Network Camera Firmware Version: V5.8.20 Release Note

Firmware Basic Information	Firmware Version:	V5.8.20 build 230309 V5.8.20 build 230328
---------------------------------------	-------------------	--

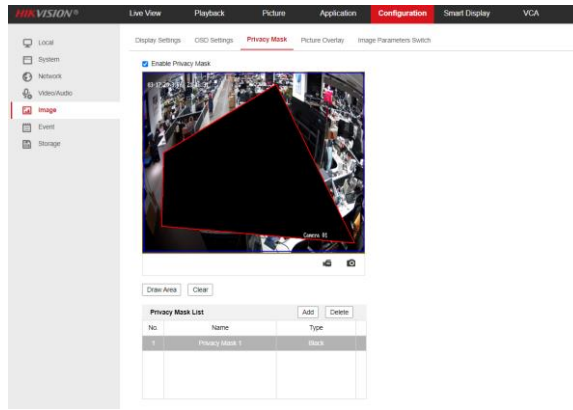
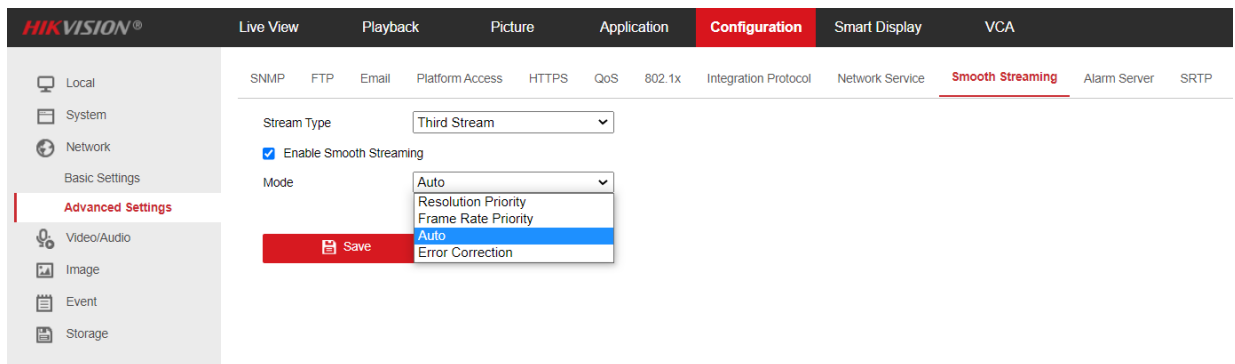
- Support drawing polygon 4-sides area of private mask.

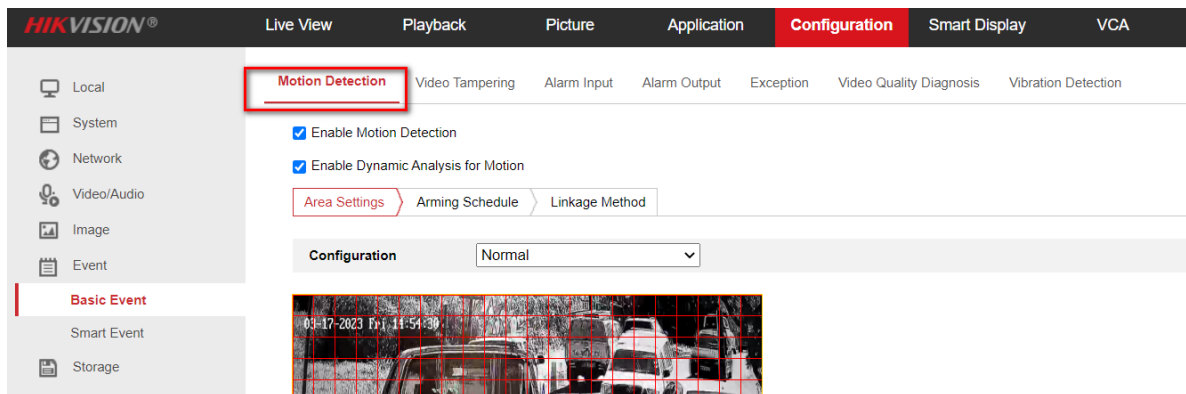
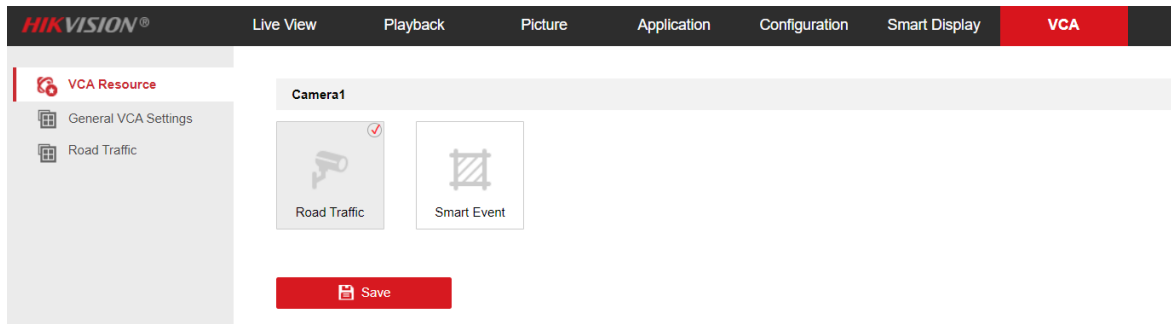
- Third Stream support NPQ (Smooth Streaming). When Smooth Streaming is enabled, functions such as, variable bitrate, MJPEG, SVC, EPTZ, and Target Cropping, are not supported.

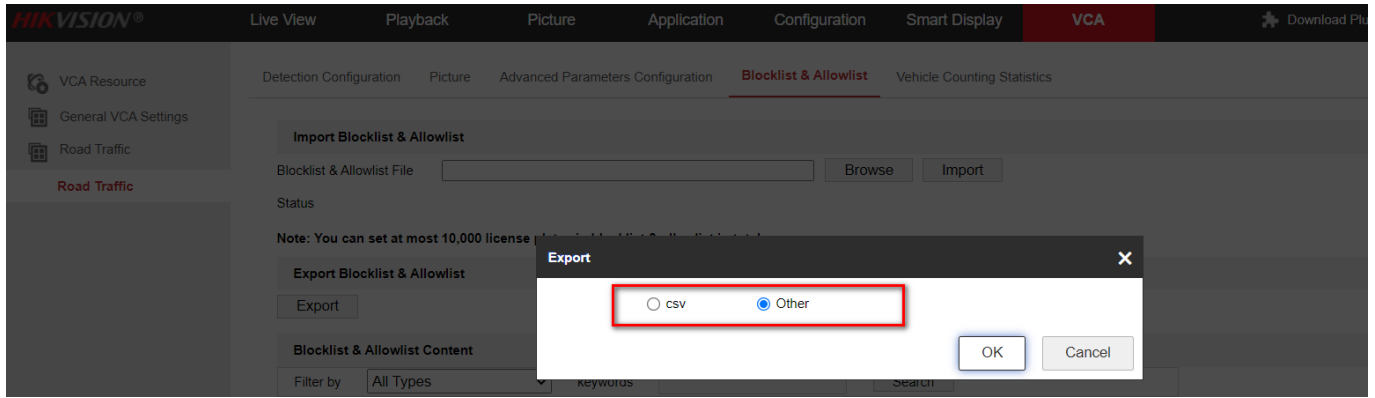
- Support motion detection on Road traffic mode. (Only supported by ANPR model (with /P))

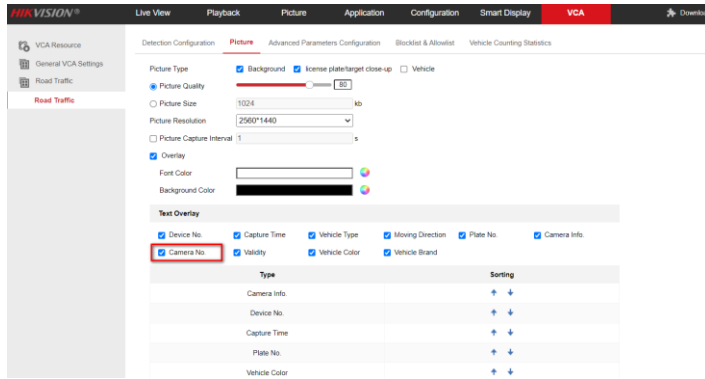
- Support high frame rate on monitoring mode. (Only supported by 2MP and 4MP model)
